100 YEAR CEQA STORM STUDY
FOR:
ROBERT KRUSE

ADDENDUM

Per 1/11/07 Scoping Letter Included

Addendum to:
100 Year CEQA Storm Study For: Robert Kruse
A.P.N. 283-011-11

Sizing & Cross Section for Vegetated Swale for TPM 21031

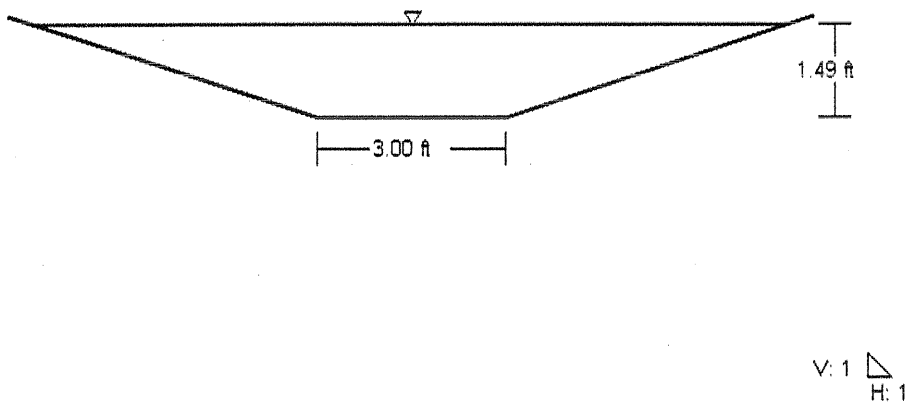
2. Include a table for pre-development versus post-development drainage showing all points of concentration (on-site and off-site) and data including a narrative on the adequacy of all drainage facilities impacted directly by proposed development.

Response: A table showing the pre and post development drainage at the northwestern corner the lowest point on the site (node 104) is shown on the next page of this addendum.
   The existing drainage facilities consist of a concrete gutter on the east side of the private road that connects to the driveway for the existing residence on Parcel 1. The concrete gutter ends at about 150 feet north of the southwest property corner and transitions into an asphalt berm. These existing drainage facilities will be improved by the proposed development using vegetated swales.

Pre-development Node	Post-development Node	Post-development Q(cfs)&V(fps)	Pre-development Q(cfs)&V(fps)
104	104	19.14 & 1.7 fps (vegetated swale)	17.80 cfs & 4.4 fps

Sheet No 36

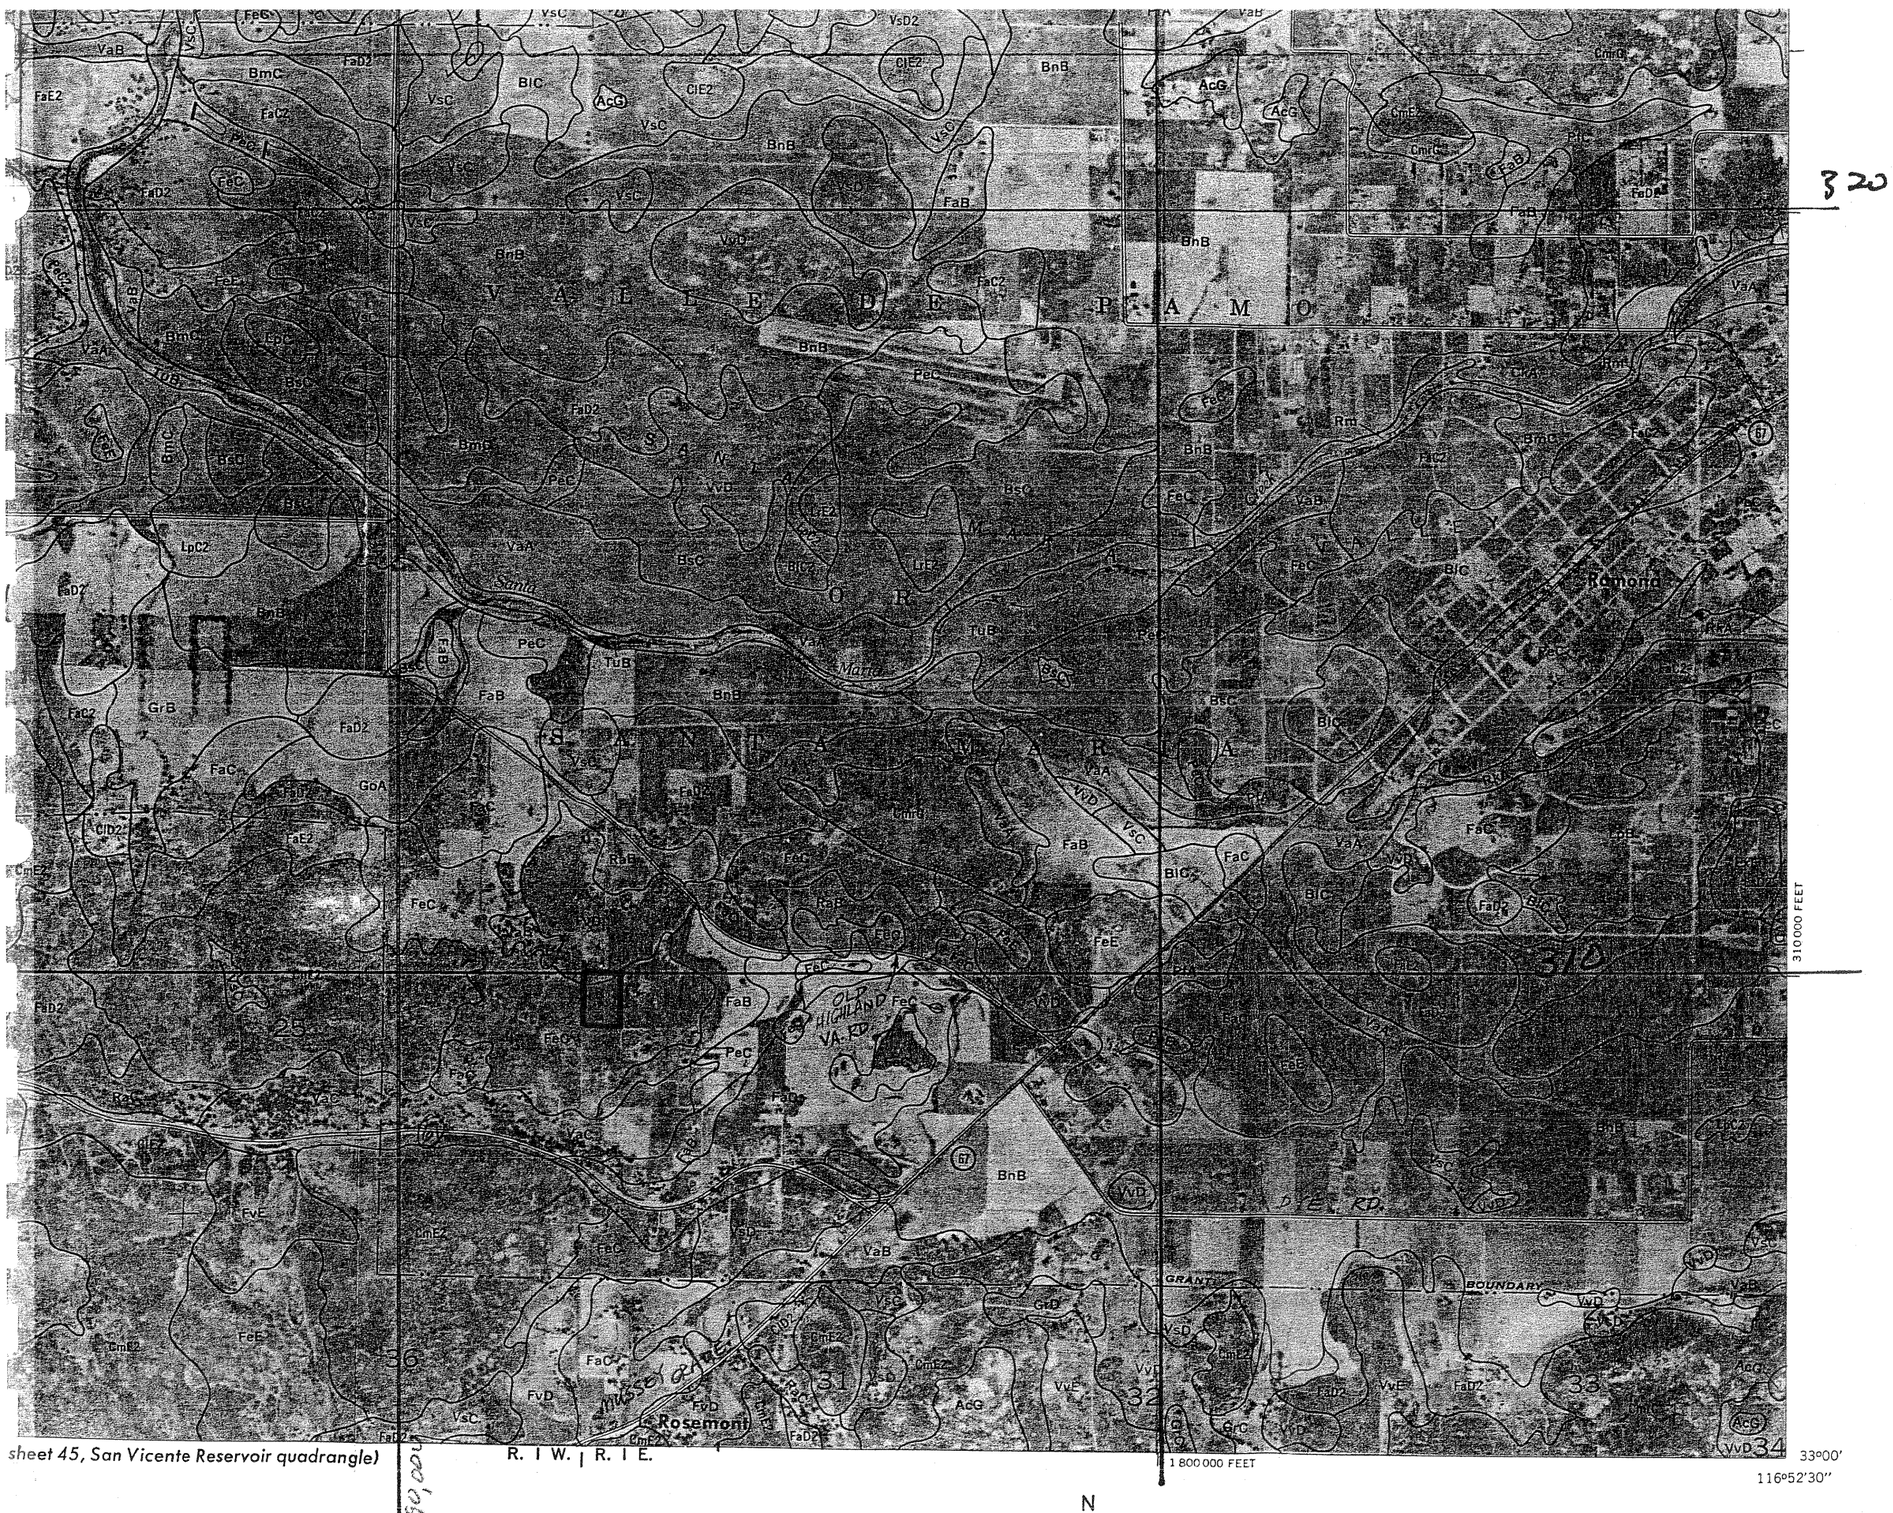
1. Include land use and soils group maps showing grids in developing "C" values. Show method/calculations of "C" values used for developed conditions.

Response: The area of watershed contributing to discharge at node 104 (northeastern corner of Parcel 2) is approximately 8.23 acres. Since neither the pre and post development land use nor the soil type vary, it is not necessary to calculate a weighted "C" value. However, this addendum does confirm that the soil of the watershed is predominately within the "C" hydrological group. This soil information from USDA's Soil Survey of San Diego County has been included in this addendum.

PRELIMINARY GRADING AND HYDROLGY PLAN FOR TPM 21301

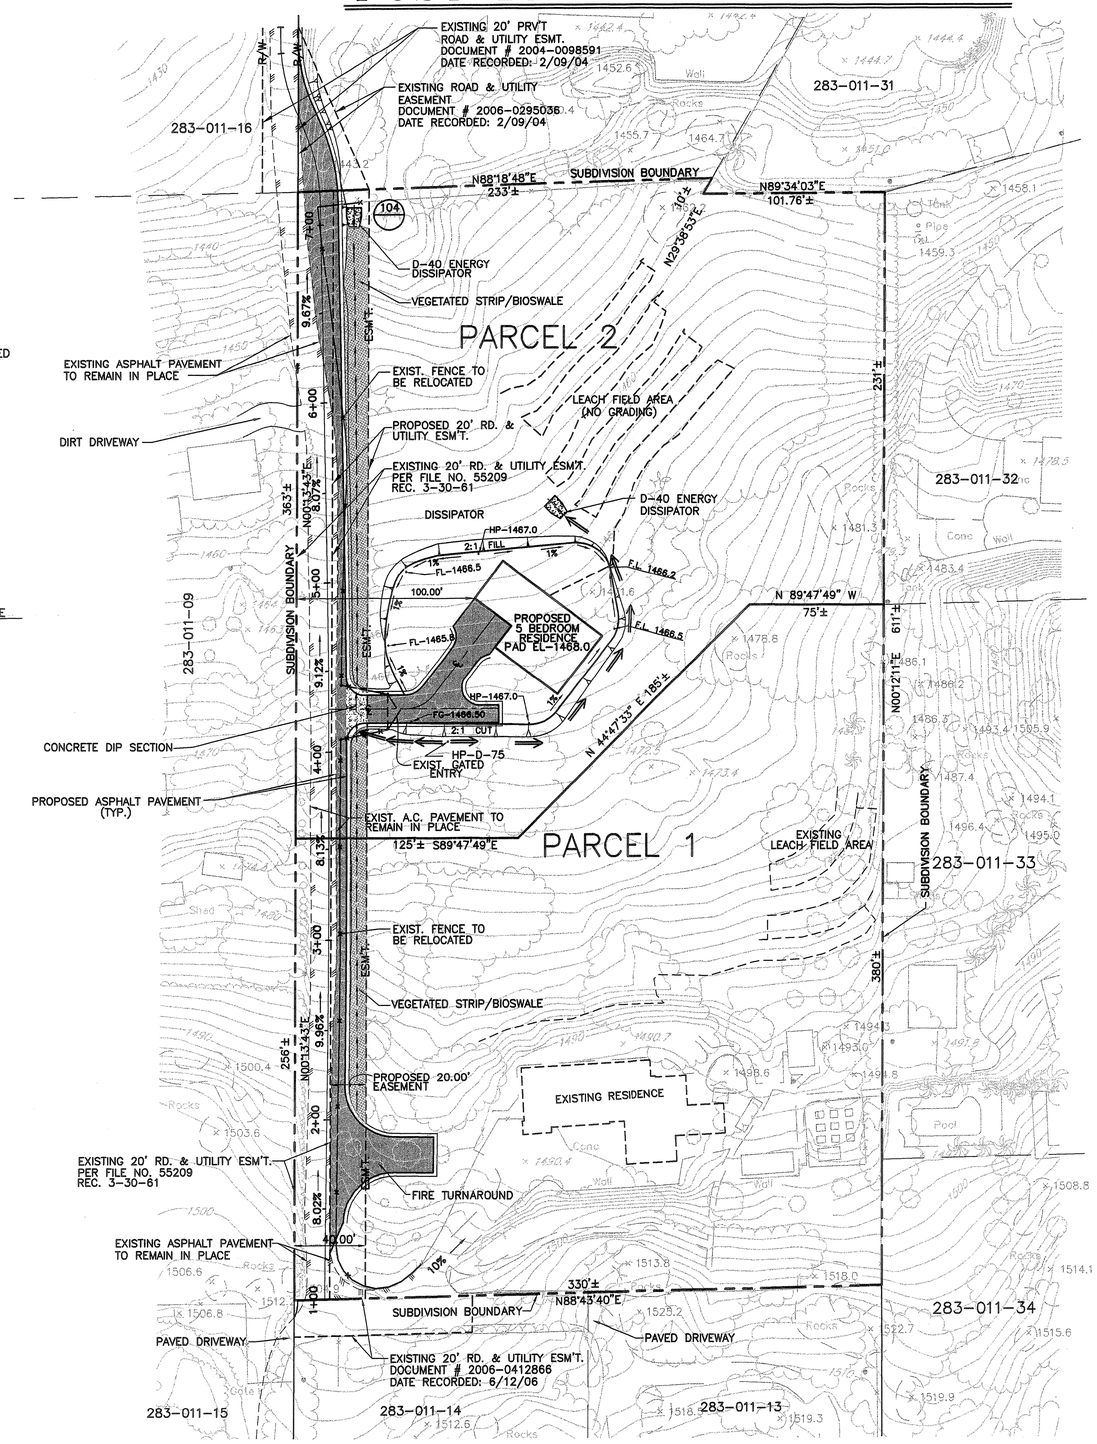
3. Address all flow paths (on-site and off-site) on hydrology map. The preliminary drainage study specifies rip rap size for "node 200" this node is not indicated on the basin map or in the hydrology

calculations. Please indicated location of node 200, also rip rap specifications shall meet current "greenbook" requirements for rock class with a given discharge velocity.

Response: Node 200 has been removed from the post-development hydrology and replaced with node 104 that coincides with node 104 of the pre-development hydrology. A post-development hydrology map has been revised because of changes to the preliminary grading plan and has been included in this report. The location of node 104 is also shown on this post-development hydrology map.
